Application for Amendment

Application under the *Agricultural Operation Practices Act* to amend a permit for a confined feeding operation, manure collection area and/or manure storage facility(ies). ("Permit" means an NRCB-issued or grandfathered approval, registration, or authorization, including a grandfathered municipal development permit.)

NRCB USE ONLY		NRCB Application number	Date Stamp
<input type="checkbox"/> Approval	<input type="checkbox"/> Registration	<input checked="" type="checkbox"/> Authorization	NRCB APPLICATION 07 AUG 2025 RECEIVED
AMENDMENT			
		LA24041A

Which permit do you wish to amend? (List permit number and issuing agency.)	LA 24 041
Legal Land Description(s)	SE 13-4-25 (Qtr-Sec-Twp-Rg-W Mer)

Dimensioned

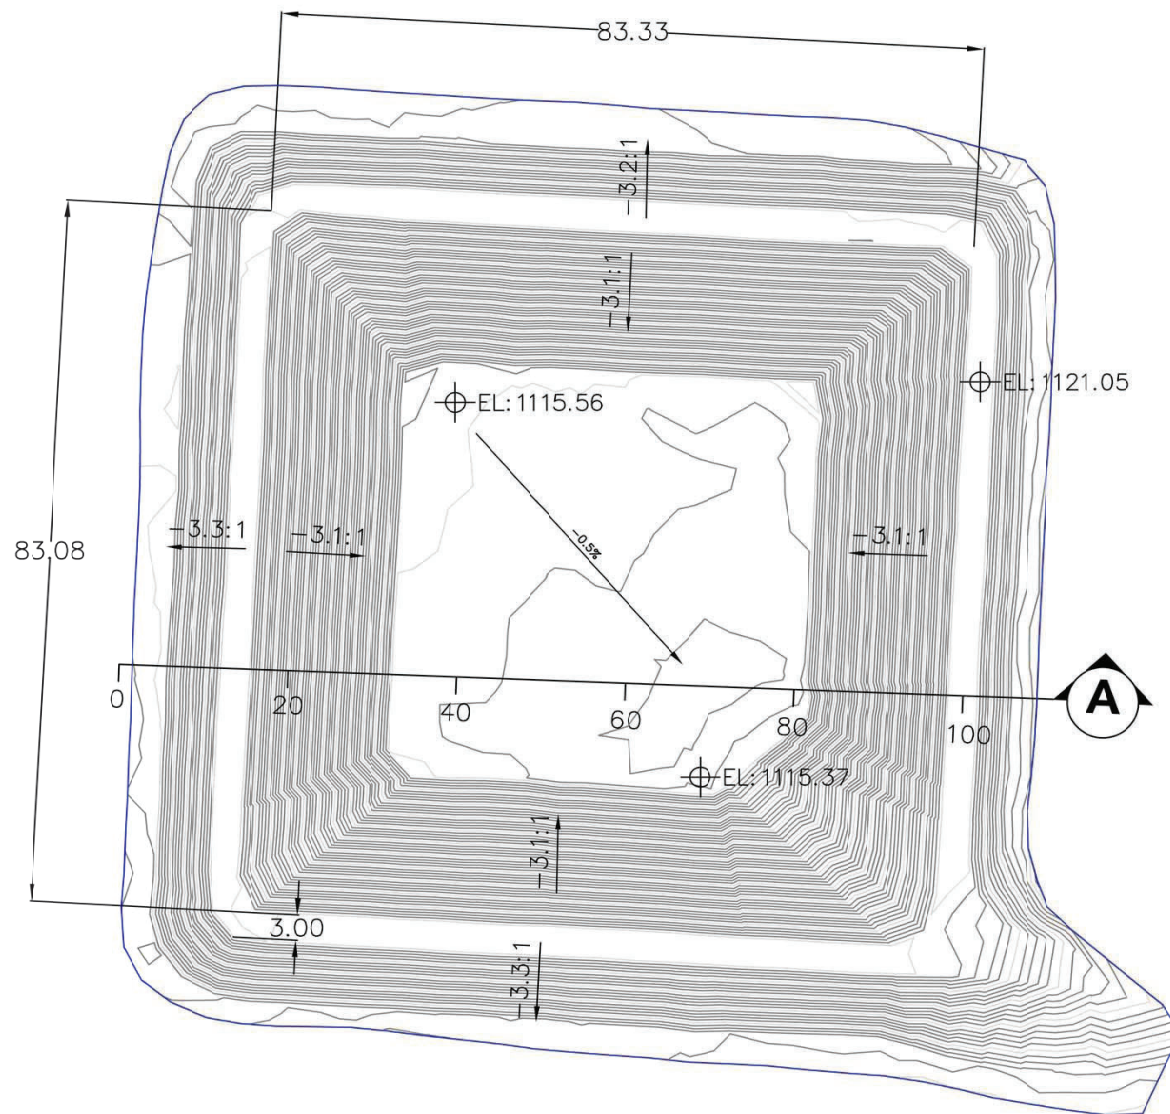
*Change dimensions of new Lagoon,
New dimension : 83 x 83 x 7M
with 3M. belowground level*

AO Comment: The dimensions of the EMS, permitted in LA24041, were 81 m x 81 m x 7 m deep. The total depth below ground level was proposed to be 7 m. The EMS, as constructed is only 3 m below ground level and 2 m wider and 2 m longer. No other changes proposed.

1. All Dimensions Metric Meters
2. Original design:
 - 81.0 m x 81.0 m x 7.0m
 - Total capacity 5,769,571 Gallons
 - Design Capacity (freeboard 0.5m) 5,074,359 Gallons
3. Constructed asbuilt:
 - Dimensions as shown
 - Colony requested sloped floor to SE as shown
 - Inner and outer slopes grades as shown
 - Top bank width as shown
 - Total Capacity (calculated using CAD) 5,406,404 Gallons
 - Asbuilt Capacity (freeboard 0.5m) 4,676,546 Gallons

Profile A

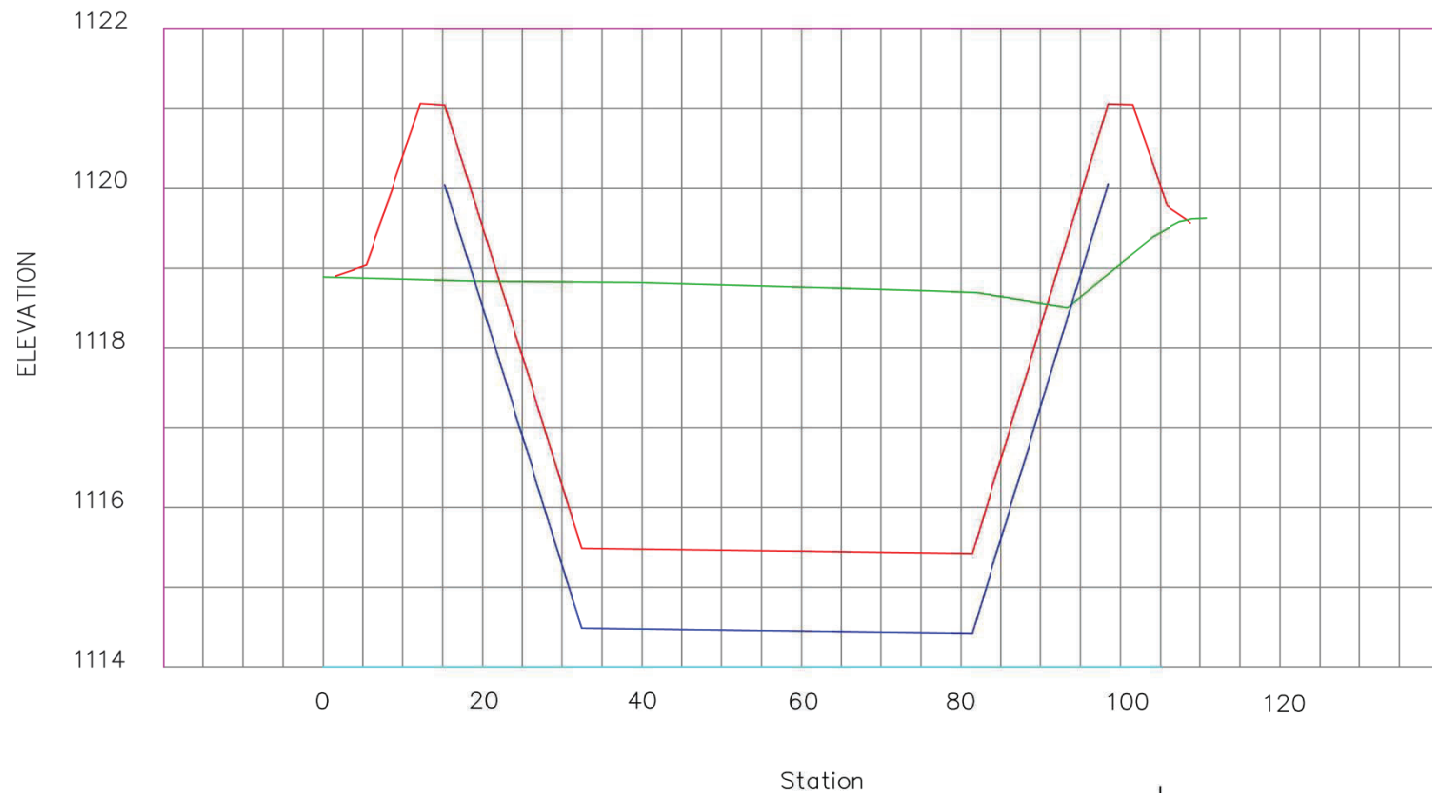
1. All Dimensions Metric Meters
2. Asbuilt Pond Profile
3. Original Ground Profile
4. Subgrade Liner
5. Water Table
 - Encountered by construction crew at elevation 1114.00
 - Surveyed in UTM, NAD 83, Zone 12 N

**(X) No water table was
encountered
within 1 m of the construction
zone during construction**
